## S E R V I C E N O T E

**E1610A 34 Mb/s E3 Line Interface for Broadband Series****Serial Numbers:** AU3336450 / AU40080500**Errors generated in 34M PLPC Mode****To Be Performed By:** Agilent-Qualified Personnel**Parts Required:** 1821-0992 XC4005 FPGA**Situation:**

Errors generated in 34M PLPC Mode

**Figure 1. Location of screws and U31**

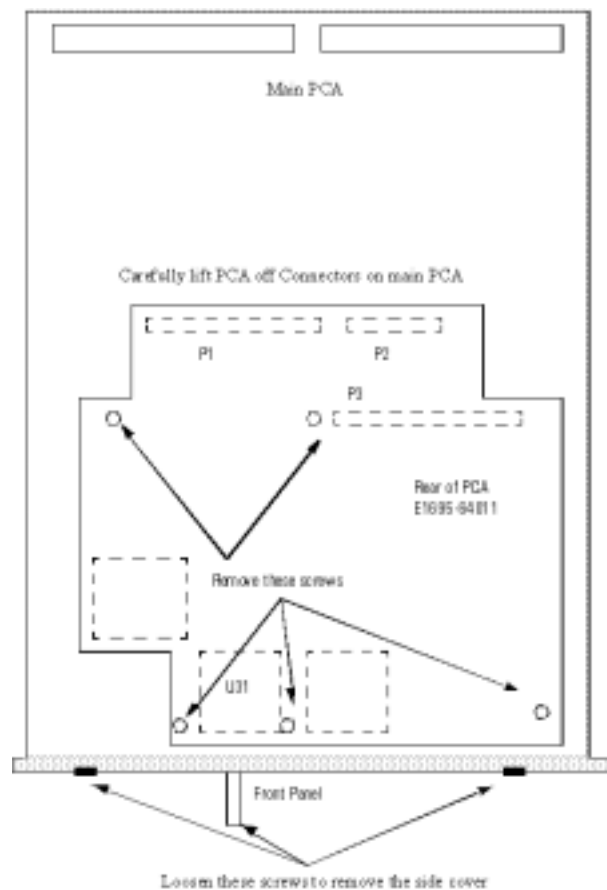
**Part Affected** Part Number: 1821-0992**Solution / Action:**

- (1) Undo the torx screws on the top shield of the module and loosen or remove the front panel screws as needed to remove the top shield.
- (2) Remove the U31 as identified in the diagram above and exchange it with the replacement part
- (3) Run the system download utility to reload the firmware into the module. (This is performed from the system mainframe using the media supplied with the system.)
